Order Instituting Rulemaking to  
Implement Dairy Biomethane Pilot  
Projects to Demonstrate Interconnection  
to the Common Carrier Pipeline System  
In Compliance with Senate Bill 1383.

R.17-06-015  
(Filed June 15, 2017)

**JOINT UTILITY REVISED DRAFT SOLICITATION**

February 15, 2018

**Figure 1: Dairy Biomethane Pilot Primary Components**

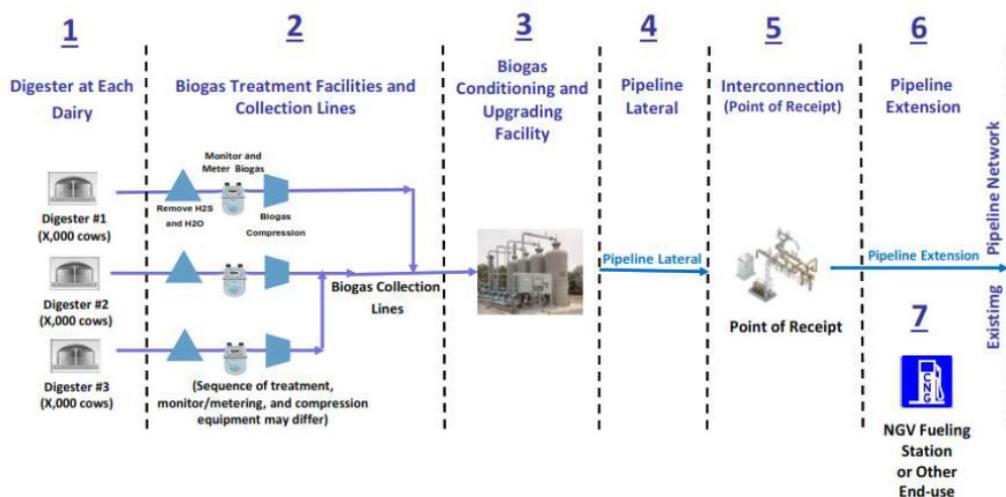
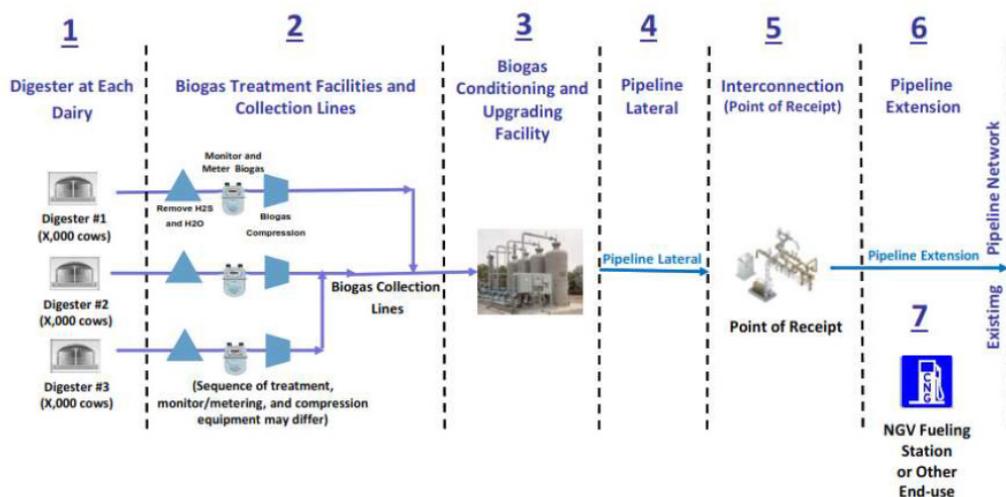
11	California Bioenergy LLC	Pages 10 and 11: "There is a change in the solicitation from the Decision. Ch. 1 Section 4.0 Figure 1: Dairy Biomethane Pilot Primary Components, Lane 2 shows H2S being removed at the dairy prior to injection into the collection/production line. Placing the upgrading system prior to collection line injection is inconsistent with the position taken by the PUC. Rather, the upgrading system belongs in Lane 3."	Yes	Clarification	<p>D. 17-12-004 states "Figure 1 is an exemplary diagram of how we understand a typical Dairy Pilot might operate".</p> <p>Figure 1 is not intended to show all potential scenarios for the removal of biogas constituents, including H2S.</p>

Applicant shall own and operate the biogas collection lines and any biogas treatment or conditioning equipment (Lane 2) to remove hydrogen sulfide and water from the raw biogas prior to it entering the biogas collection lines. Applicant owned and operated gas gathering lines are regulated under California Code of Regulations (CCR) Title 8 Industry Safety Regulations<sup>5</sup>. The upfront costs<sup>6</sup> associated with the biogas collection lines and treatment equipment will be recovered from utility ratepayers and provided as a reimbursement to the Applicant. To ensure only reasonable and verified costs of Pipeline Infrastructure developed pursuant to the dairy Pilot Projects are collected from ratepayers, Applicant-owned Pipeline Infrastructure costs will be recorded in a Utility balancing account and costs above the bid amount will be subject to reasonableness review by the CPUC<sup>7</sup>. Selected Pilot Projects should keep detailed project and cost information, and be prepared to provide this information should a reasonableness review be necessary.
